Technical Service Information

THM 4L80-E CENTER GEAR BOX CHANGES FOR 1999 MODELS ("REVISED INFORMATION")

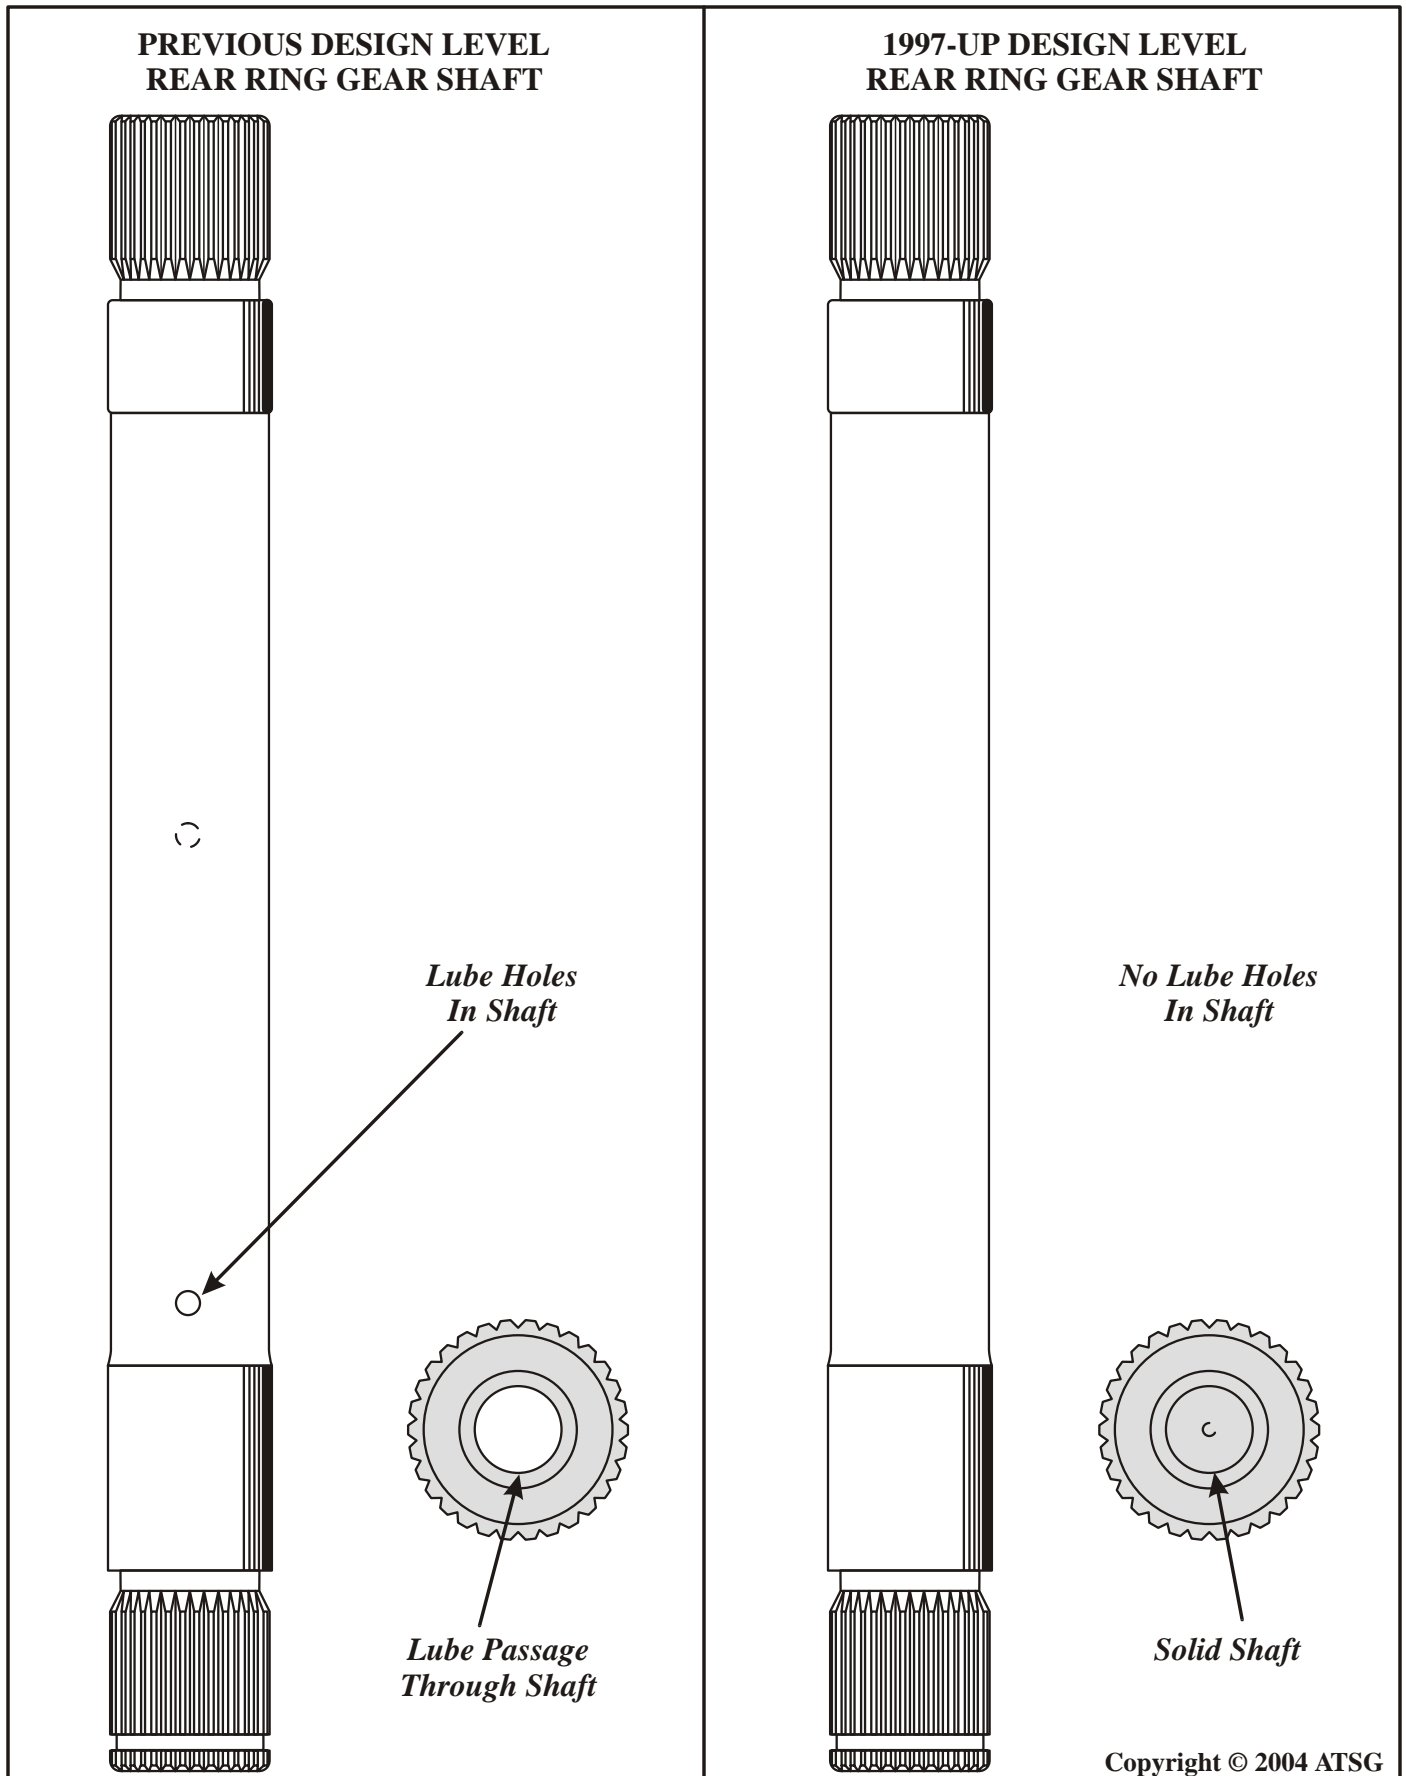
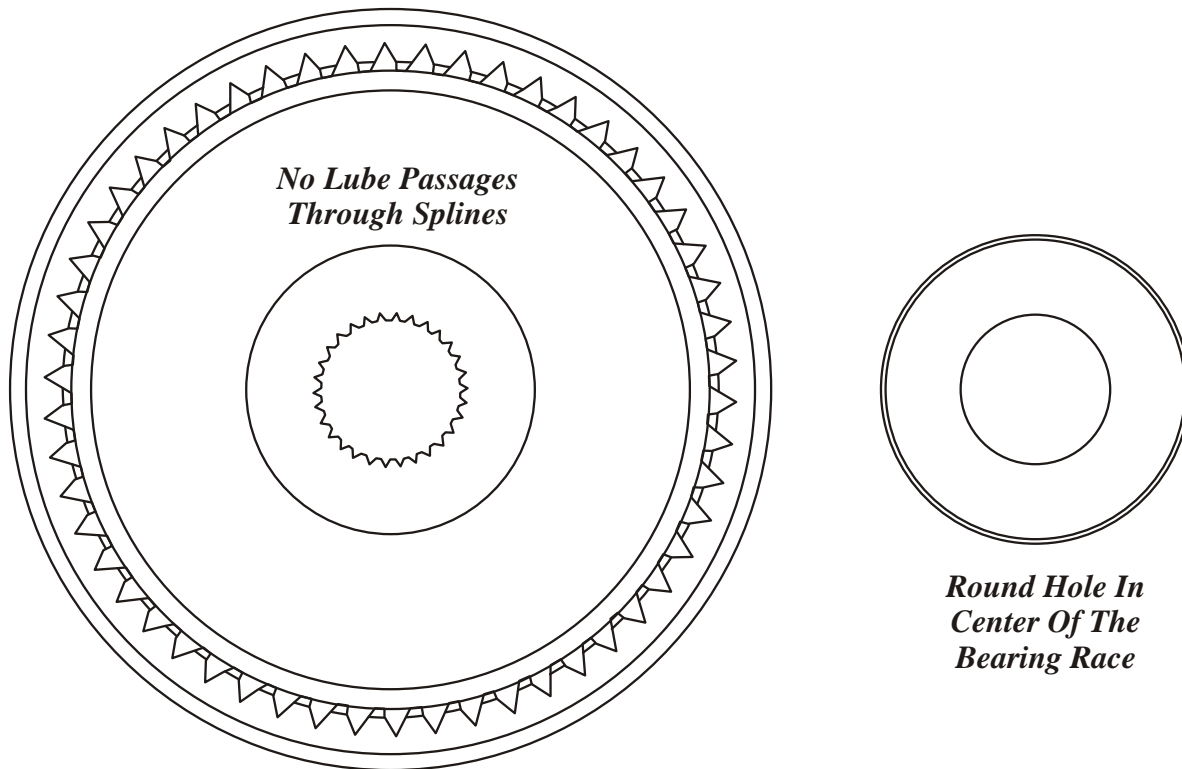
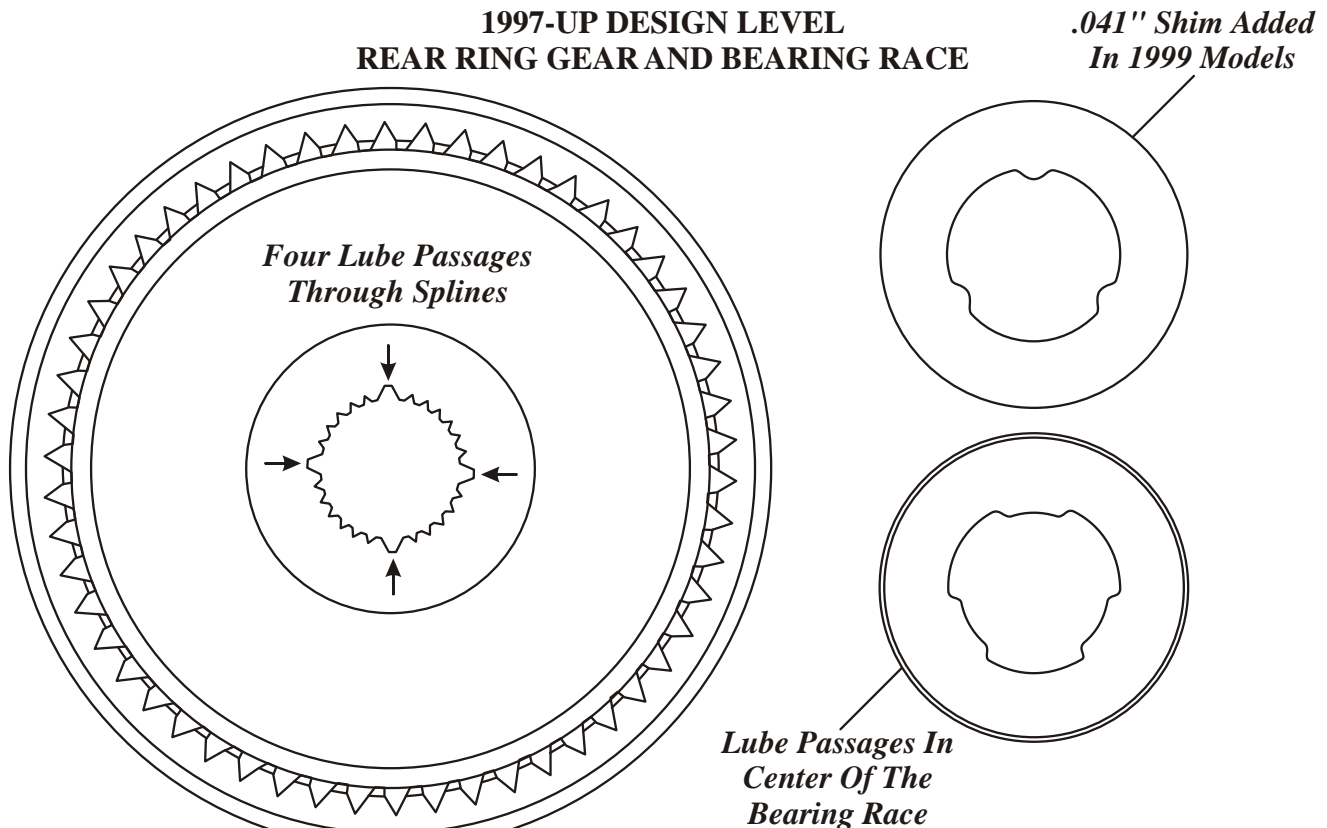
The Sun Gear, Main Shaft, Rear Internal Ring Gear and all Thrust Bearings remained the same, as shown in Figures 5, 6, and 7.

Figure 8

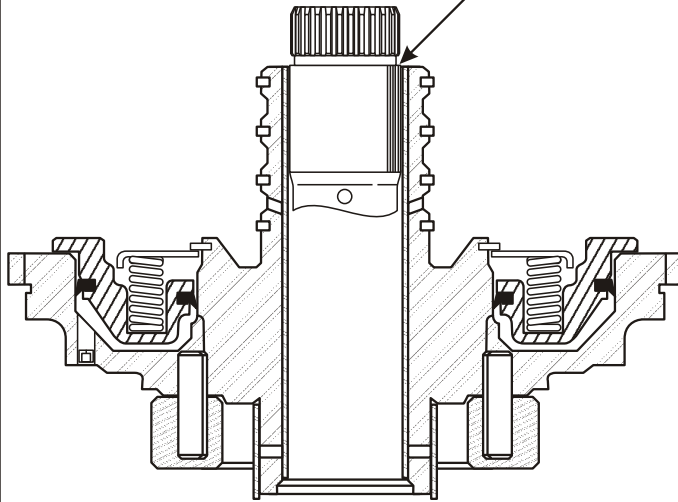
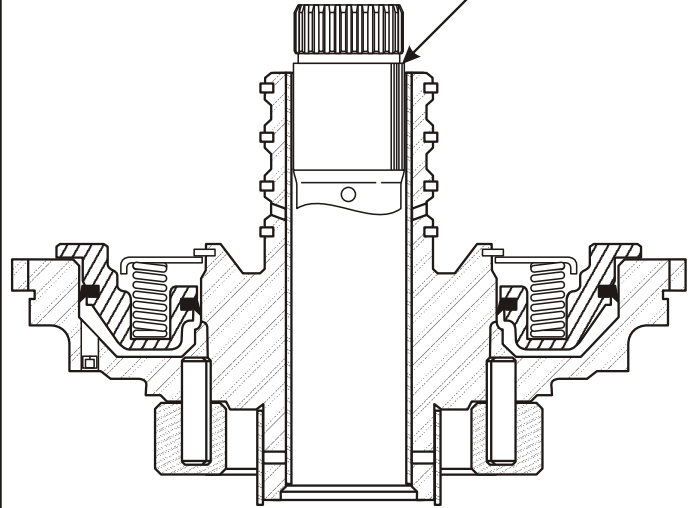
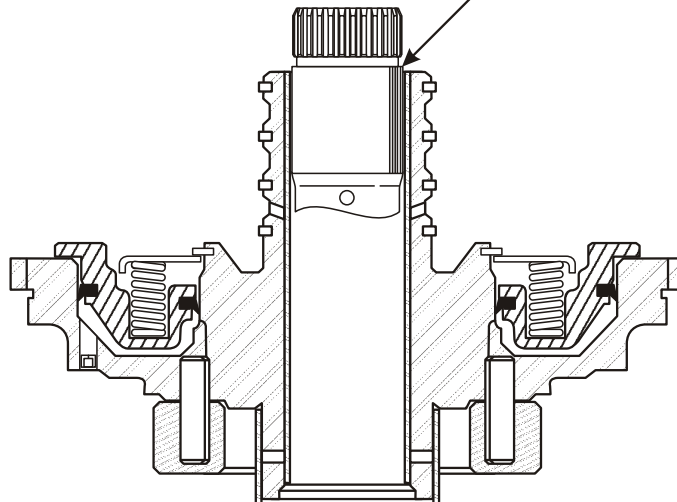
SPECIAL NOTE: Some mis-assembly examples are illustrated in Figure 8 with some dimensional checks to prevent this from happening to you.

1999 SUN GEAR SHAFT
WITH 1997-98 CENTER SUPPORT
AND NO .041" SHIM

*Shaft Journal
Approximately
Flush With Support*

1997-98 SUN GEAR SHAFT
WITH 1999 CENTER SUPPORT
AND WITH .041" SHIM

*Shaft Journal
Approximately
.090" Above Support*

"CORRECT ASSEMBLY"
WITH PROPER
SUN GEAR SHAFT
AND CENTER SUPPORT

*Shaft Journal
Approximately
.050" Above Support*
